STATE OF ALASKA
DEPARTMENT OF TRANSPORTATION AND PUBLIC FACILITIES

Hoonah Alaska

GENERAL LAYOUT

PROJECT NUMBER X 70006 SHEET 2 OF 6

1/22/85		DO NOT SCALE THIS DRAWING - USE DIMENSIONS	
STAMP		STATE OF ALASKA	
		DEPARTMENT OF TRANSPORTATION AND PUBLIC FACILITIES	
		Alaska	
Hoanah		FENDER PLAN & ELEVATION	
DESIGNED LVB	CHECKED JS	DRAWN LVB	DATE 10/84
PROJECT NUMBER X70006	SHEET 3		OF 6

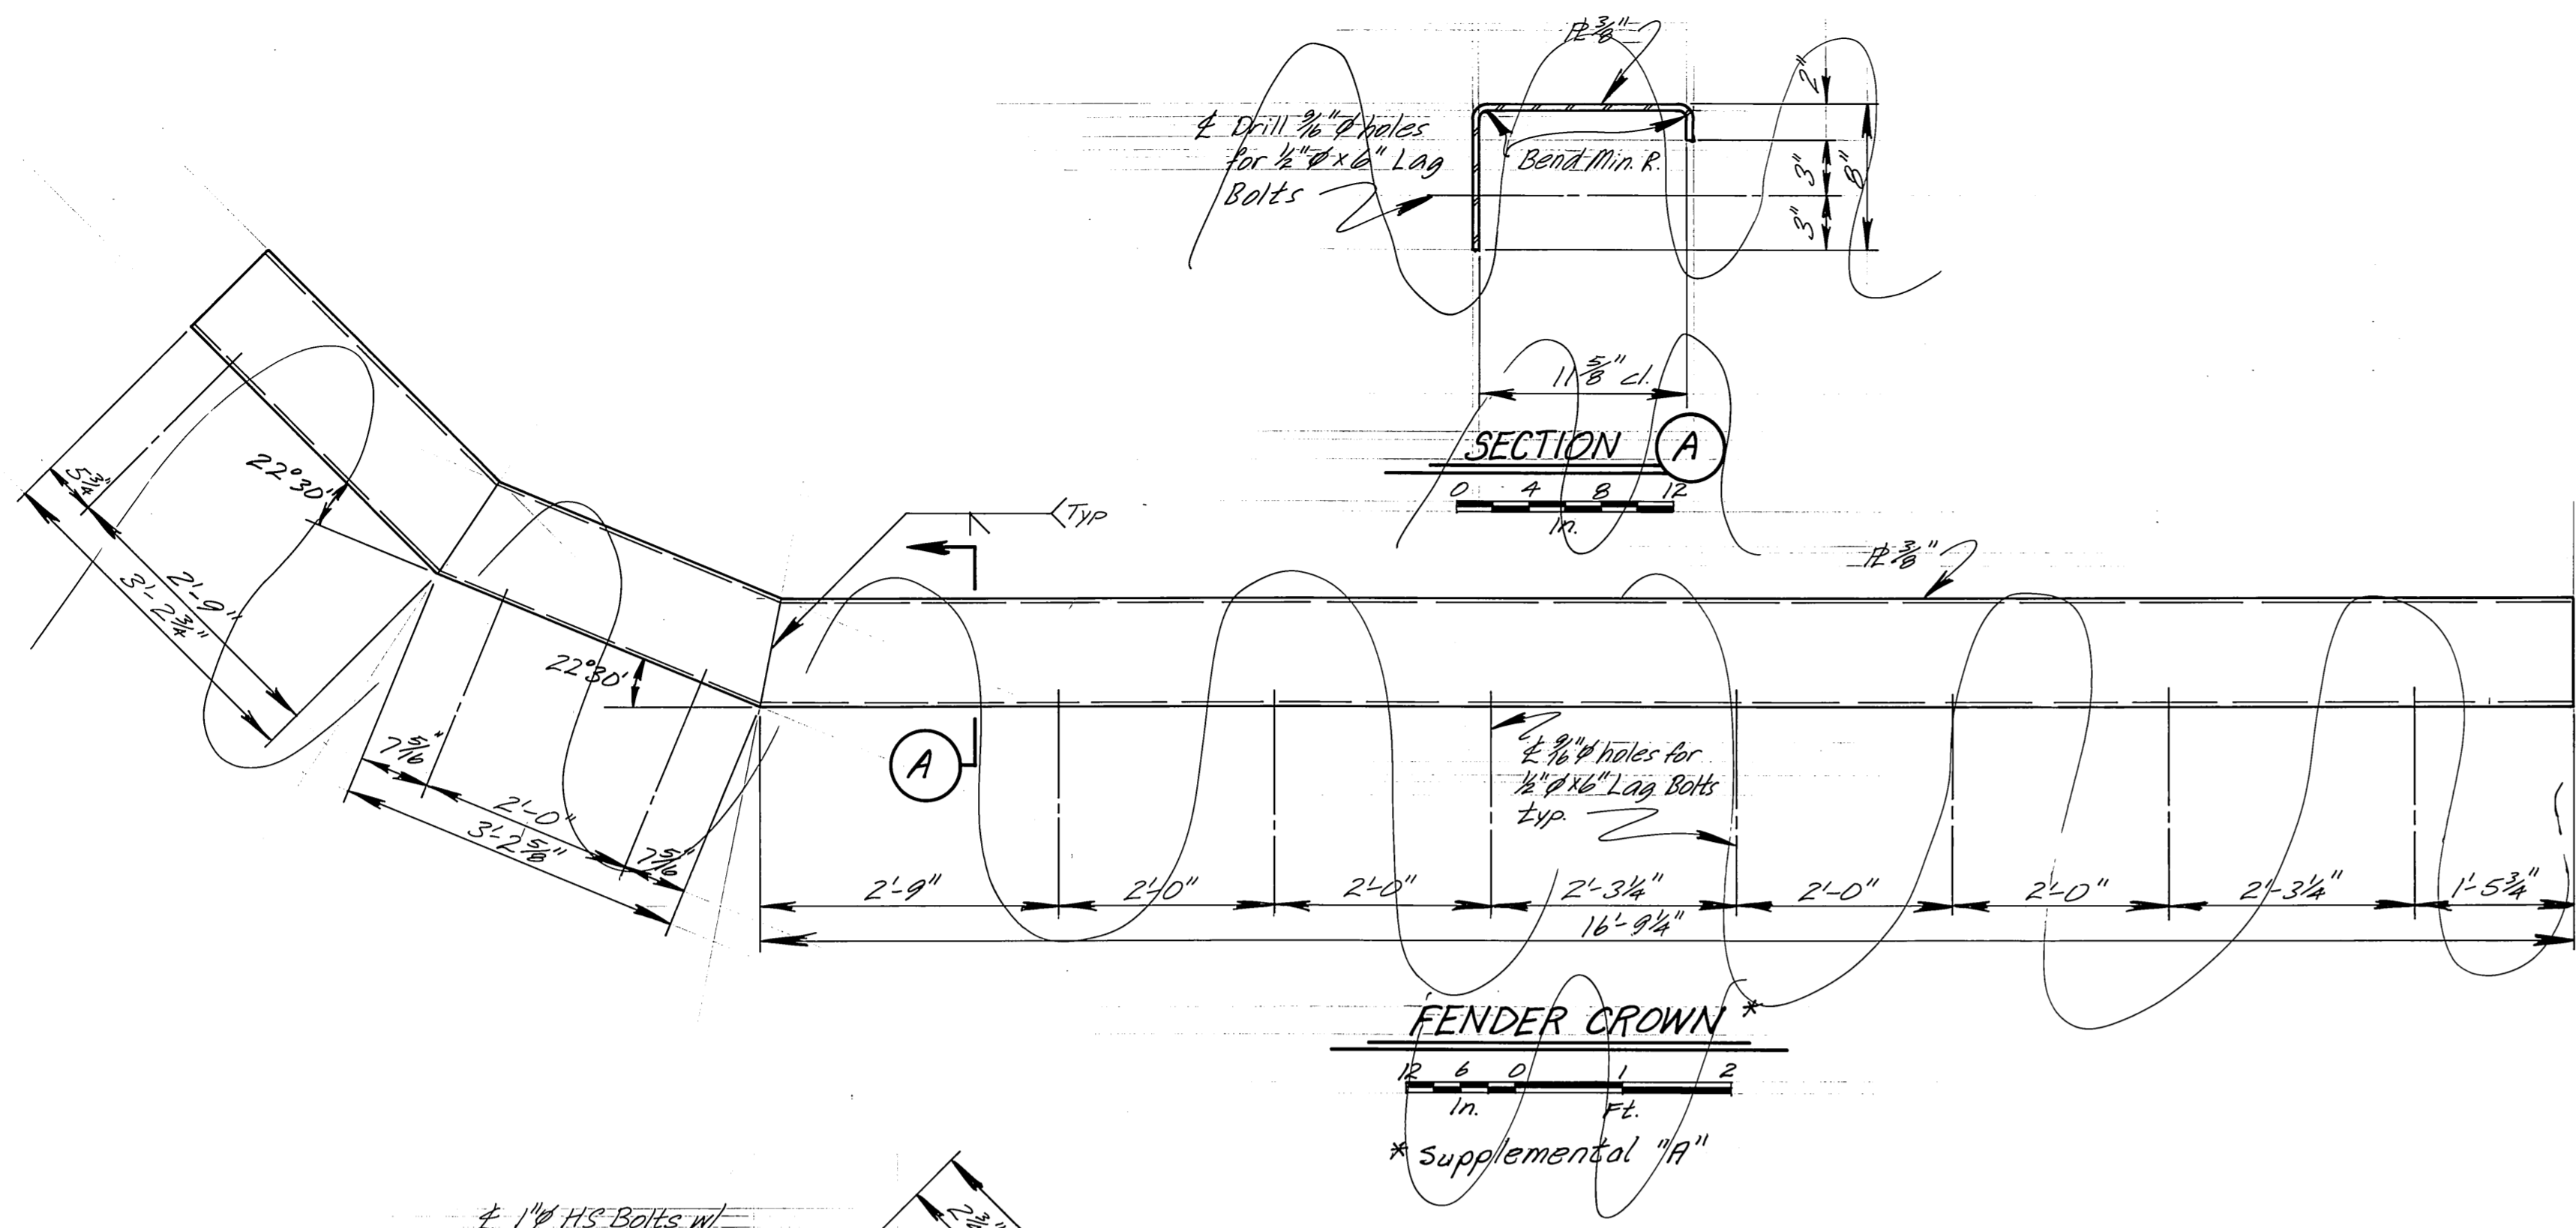
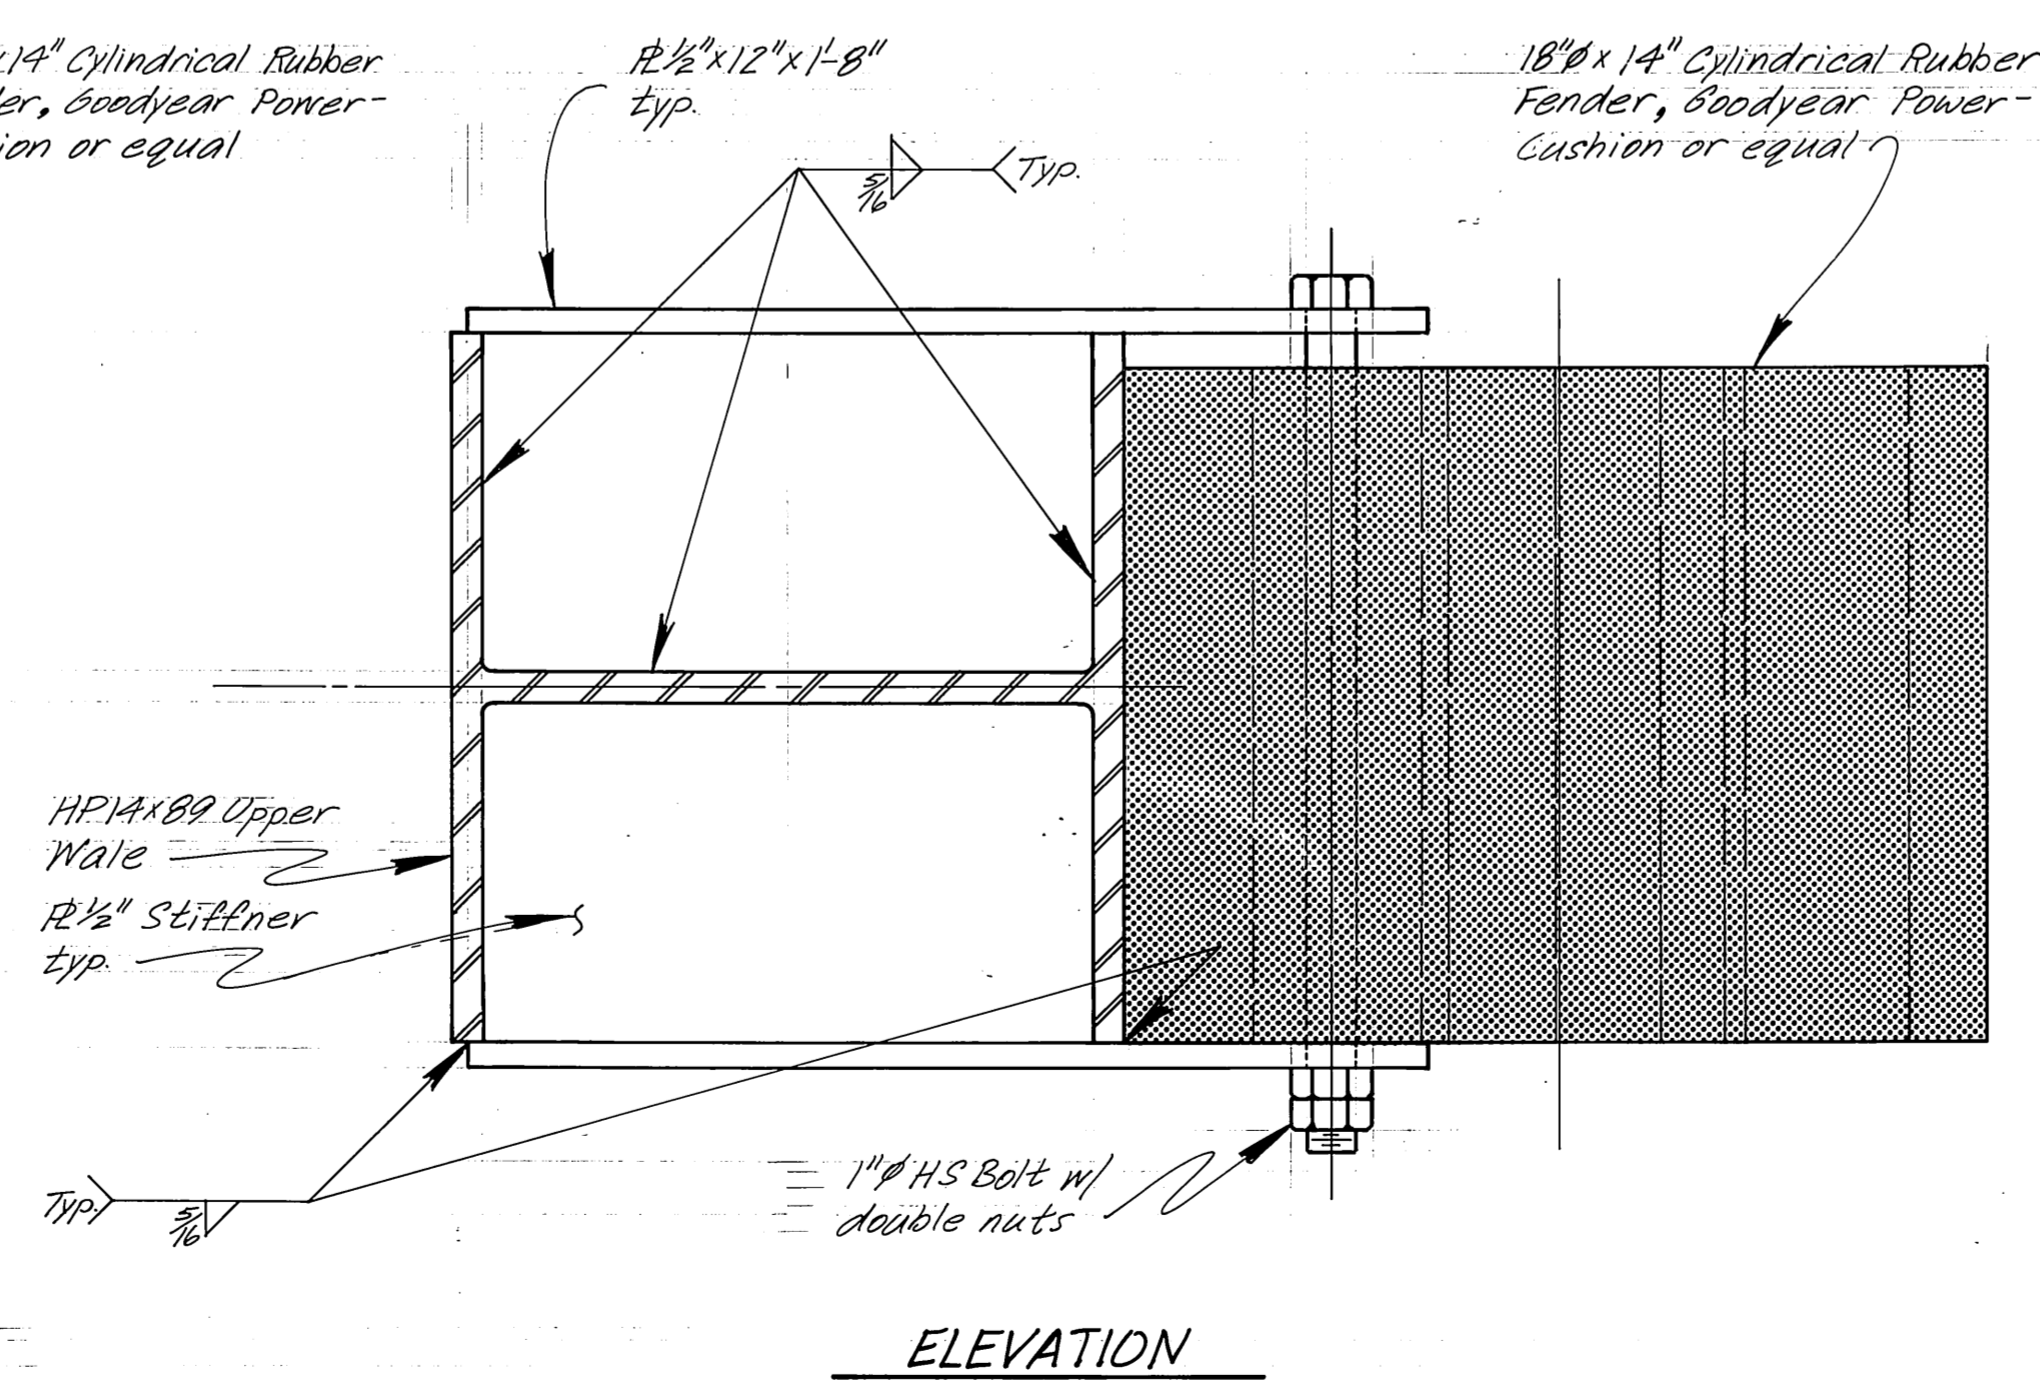
AS BUILT NOTE: Supplement "A" not awarded. 18" O.D. x 9" I.D. rubber fender substituted.
